SUBJECT: Transmittal of Changes to Fort Calhoun Radiological Emergency Response Plan (RERP) and Emergency Plan Implementing Procedures (EPIP) Manuals

Confirmation of Transmittal for
Emergency Planning Documents/Information

The procedures listed above were revised to update the format, change CID numbers to AR numbers and delete references to the TSC Dose Assessment Coordinator and TSC Chemistry Liaison positions. In addition to these changes the following revisions were made:

FIGURE H-2 TYPICAL TECHNICAL SUPPORT CENTER LAYOUT

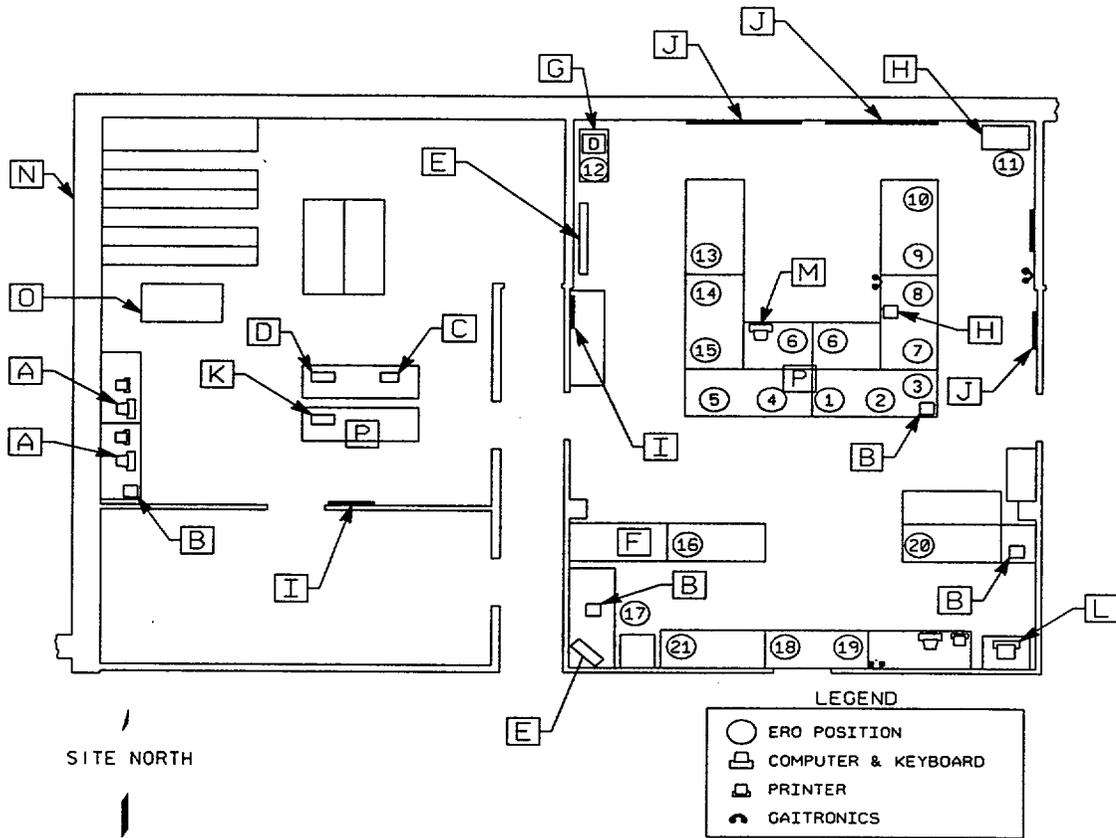
Reason for Change: Change Figures H-2, H-3 and H-4 to reflect removal of the TSC Dose Assessment Coordinator and TSC Chemistry Liaison position from the ERO. Other minor changes to the OSC, TSC and EOC are also included.
